# UNITED STATES PATENT AND TRADEMARK OFFICE

APPLICATION NO.	FILING DATE	FIRST NAMED INVENTOR	ATTORNEY DOCKET NO.	CONFIRMATION NO.
10/756,977	01/13/2004	Alan D. Kersey	CC-0700	3781

**Office Action Summary**

FIG. 12

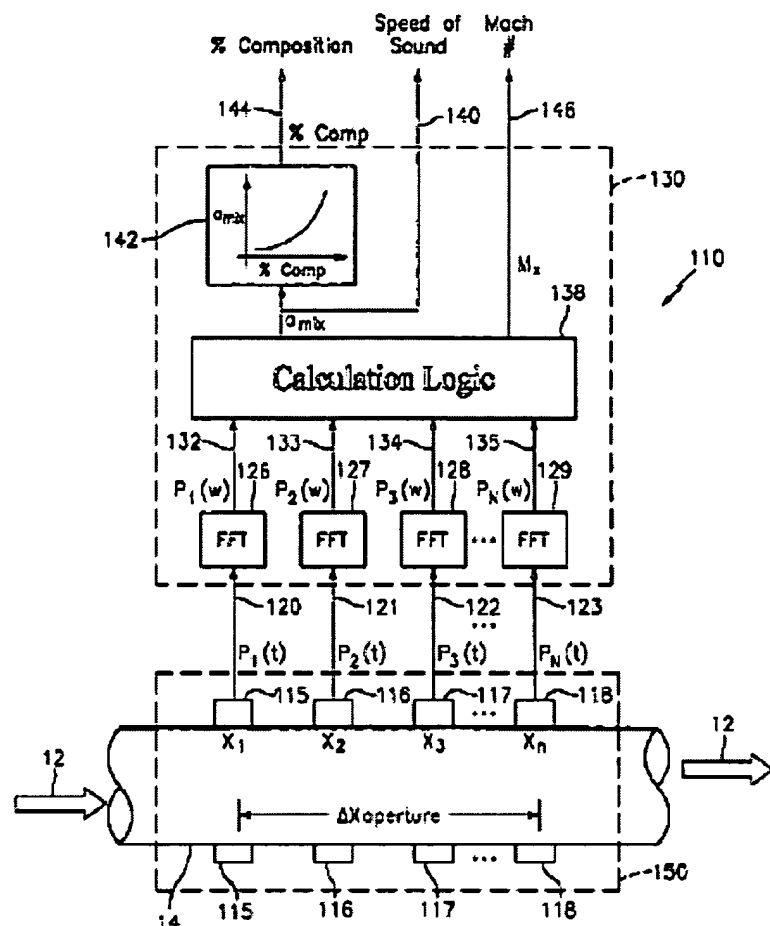
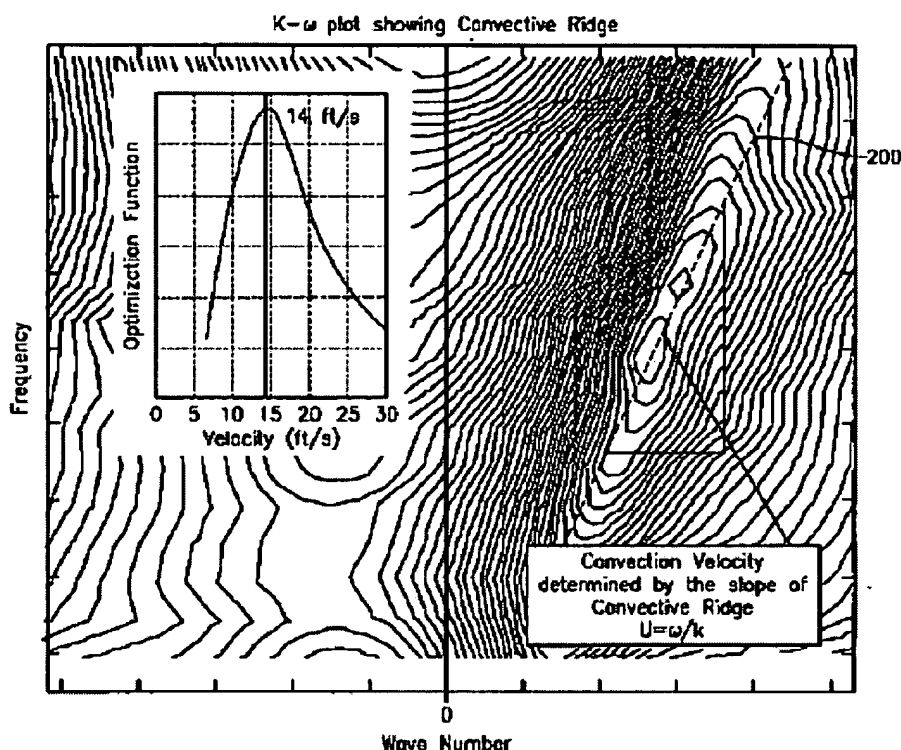
Fernald discloses a method for measuring the flow velocity of a fluid flowing through a conduit, the method comprising: providing an array of at least two ultrasonic sensors disposed at predetermined locations along longitudinal direction of the conduit (fig. 12, unit 115, 116, 117, 118) each ultrasonic sensor providing a respective sensors signal indicative of a parameter of an ultrasonic signal propagation through the fluid (page 2, section 0012-0014, fig. 12, unit 12, 150); processing the sensor signals to define a convective ridge in the k-w plane (page 10, section 0124); and determining the slope of at least a portion of the convective ridge to determine the flow velocity of the fluid (page 10, section 0124, fig. 16).

Fernald discloses an apparatus for measuring the flow velocity of a fluid flowing through a conduit, the apparatus comprising: an array of at least two ultrasonic sensors unit disposed at predetermined locations along the conduit along a longitudinal direction of the conduit (fig. 12, section 115, 116); each ultrasonic sensor providing a respective sensor signal indicative of a parameter of an ultrasonic signal propagating through the fluid; a processor that defines a convective ridge in the k-w plane in response to the sensor signals (page 10, section 0124), and determines the slope of at least a portion of the convective ridge to determine the flow velocity of the fluid (page 10, section 0124, fig. 16).

Fernald discloses an apparatus for measuring the flow velocity of a fluid flowing through a conduit, the apparatus comprising: an array of at least two ultrasonic sensors disposed at predetermined locations along the conduit along a longitudinal direction of the conduit (fig. 12, section 115, 116), each ultrasonic sensor providing a respective sensor signal indicative of a parameter of an ultrasonic signal propagating through the fluid (page 2, section 0012-0014); means for processing the sensor signals to define a convective ridge in the k-w

Fernald discloses an apparatus for measuring the flow velocity of a fluid flowing through a conduit, the apparatus comprising: an array of at least three ultrasonic sensors disposed longitudinally at predetermined locations along the conduit along a longitudinal direction of the conduit (fig. 12, section 115, 116), each ultrasonic sensor providing a respective sensor signal indicative of a parameter of an ultrasonic signal propagating through the fluid; and a processor (fig. 12, unit

Fernald discloses an apparatus for measuring the flow velocity of a fluid flowing through a conduit, the apparatus comprising: an array of at least two ultrasonic sensors disposed longitudinally at predetermined locations along the conduit (fig. 12, section 115, 116), each ultrasonic sensor providing a respective sensor signal indicative of a parameter of an ultrasonic signal propagating through the fluid substantially orthogonal to the direction of the fluid flow (fig. 12, section 115, 116); and a processor (fig. 12, unit 138), in response to the sensor signals, that determines the flow velocity of the fluid (page 10, section 0124, fig. 16).

Fernald discloses an apparatus for measuring the flow velocity of a fluid flowing through a conduit, the apparatus comprising: an array of at least two ultrasonic sensors disposed longitudinally at predetermined locations along the conduit (fig. 12, section 115, 116), each ultrasonic sensor providing a respective sensor signal indicative of a parameter of an ultrasonic signal propagating through the fluid; and a processor using an array processing algorithm to determine the flow velocity of the fluid (page 10, section 0124, fig. 16).

Regarding claim 18, Fernald further discloses each ultrasonic sensor includes an ultrasonic receiver ' which are disposed such that the ultrasonic signal propagating there between is orthogonal to the direction of the fluid flow (page 3, section 0042, fig. 12, unit 115-118, abstract); Regarding claim 37, Fernald further discloses included receiver (page 3, unit 0034); Regarding claim 38, Fernald further discloses the ultrasonic receiver of each ultrasonic sensor are disposed opposing each other such that the ultrasonic signal propagates through the fluid substantially orthogonal to the direction of the fluid flow (fig. 12, unit 115, 116, 117, 118); Regarding claim 27, Fernald further discloses sensors are disposed in pitch-catch configuration and receiver are mounted opposing each other (fig. 12,

unit 115, 116); Regarding claim 39, Fernald further discloses each ultrasonic sensor includes an ultrasonic unit having an ultrasonic receiver (page 3, unit 0034, fig. 12, 115); Regarding claim 40, Fernald further discloses ultrasonic signal that propagates through the fluid substantially orthogonal to the direction of the fluid flow, which reflects back substantially orthogonal to the direction of the fluid flow to the receiver of each ultrasonic unit (fig. 12, unit 115, fig. 2, unit 12);

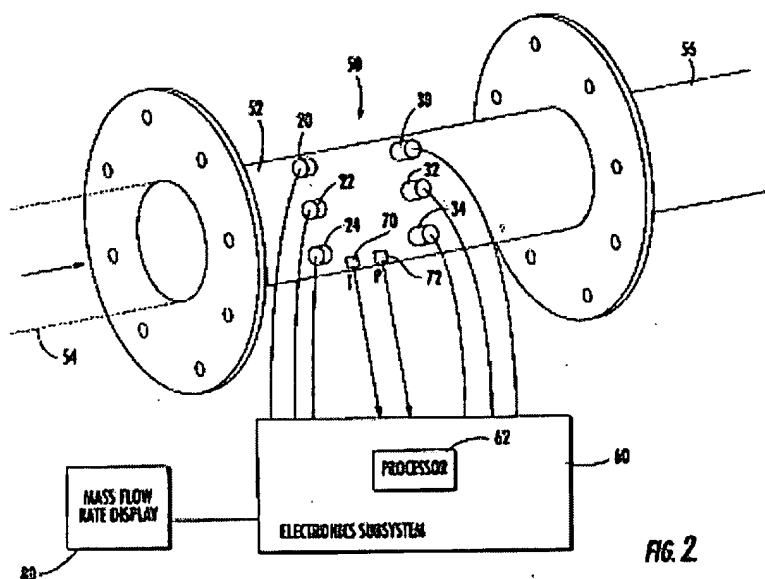
Lynnworth discloses an apparatus for measuring the flow velocity of a fluid flowing through a conduit, the apparatus comprising: an array of at least three ultrasonic sensors (fig. 2, unit 20, 22, 24, 30, 32, 34) disposed longitudinally at predetermined locations along the conduit along a longitudinal direction of the conduit (page 2, section 0021-0023), each ultrasonic sensor providing a respective sensor signal indicative of a parameter of an ultrasonic signal propagating through the fluid (page 2, section 0021-0023); and a processor (fig. 2, unit 62), in response to the sensor signals, that determines the flow velocity of the fluid (page 2, section 0021-0023, abstract).

conduit (fig. 2, unit 20, 22, 24, 30, 32, 34, page 2, section 0021-0023), each ultrasonic sensor providing a respective sensor signal indicative of a parameter of an ultrasonic signal propagating through the fluid substantially orthogonal to the direction of the fluid flow (page 2, section 0021-0023); and a processor (fig. 2, unit 62), in response to the sensor signals, that determines the flow velocity of the fluid (page 2, section 0021-0023, abstract).

Lynnworth discloses an apparatus for measuring the flow velocity of a fluid flowing through a conduit, the apparatus comprising: an array of at least two ultrasonic sensors disposed longitudinally at predetermined locations along the conduit (fig. 2, unit 20, 22, 24, 30, 32, 34, page 2, section 0021-0023), each ultrasonic sensor providing a respective sensor signal indicative of a parameter of an ultrasonic signal propagating through the fluid (fig. 2, unit 20, 22, 24, 30, 32,

34, page 2, section 0021-0023); and a processor (fig. 2, unit 62) using an array processing algorithm to determine the flow velocity of the fluid (page 2, section 0021-0023).

**B.** Applicant continues to argue that Lynnworth does not show the 'a respective sensor signal indicative of a parameter of an ultrasonic signal propagating through the fluid orthogonal to the direction of the fluid'. Lynnworth discloses clearly 'a respective sensor signal indicative of a parameter of an ultrasonic signal propagating through the fluid orthogonal to the direction of the fluid' in page 2, section 0023, page 3, section 0042, fig. 2, unit 54.
